Multiplexing Extended Header Format for 802.16m

Document Number: C80216m-09_0394

CR to SDD as per configuration control procedure (80216m-09_0008)

Discuss and approve the proposed text changes into SDD document

Figure x: Multiplexing Extended header for 16m

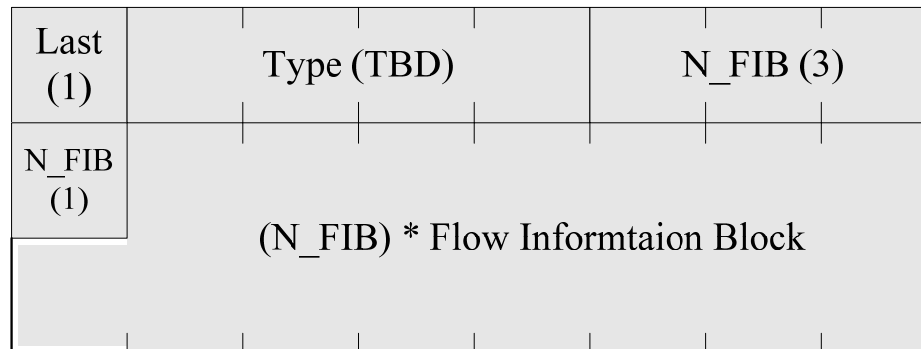
[Insert the following text in section 10.12.2.2 in IEEE 802.16m-08/003r7]

IEEE 802.16m supports multiplexing of multiple connections payloads belonging to same AMS in a single MAC PDU. GMH contains the flow identifier and length of the 1st connection payload in a MAC PDU. Multiplexing extended header (MEH) contains the flow identifiers and lengths of remaining connections payloads multiplexed in a MAC PDU. The multiplexing extended header is shown in figure x. MEH, if present, is the first extended header present in the MAC PDU. MEH consists of one or more flow information blocks (FIBs). The number of FIBs in MEH is equal to number of connection payloads multiplexed in the MAC PDU minus one.

Figure y: Flow Information Block

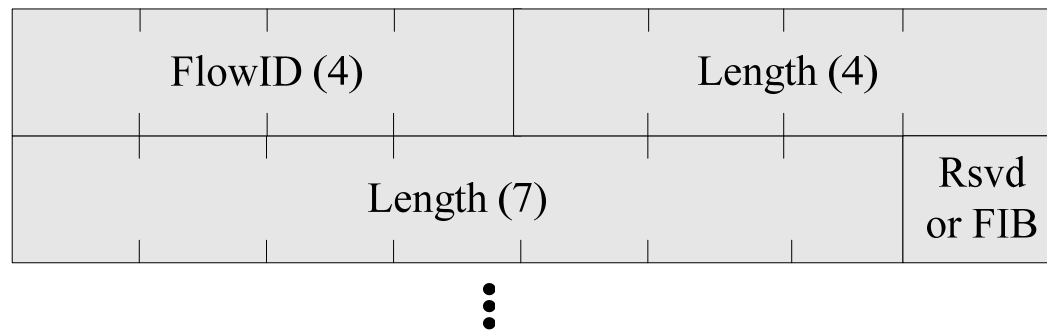
The flow information block is shown in figure y. The 'nth' FIB in MEH contains the flow identifier and length of 'n+1'th connection payload in a MAC PDU. .

- FlowID : Flow Identifier*
- Length: Length of payload.*
- Rsvd: Reserved bits are added at the end of last FIB in MEH to octet align the MEH.*
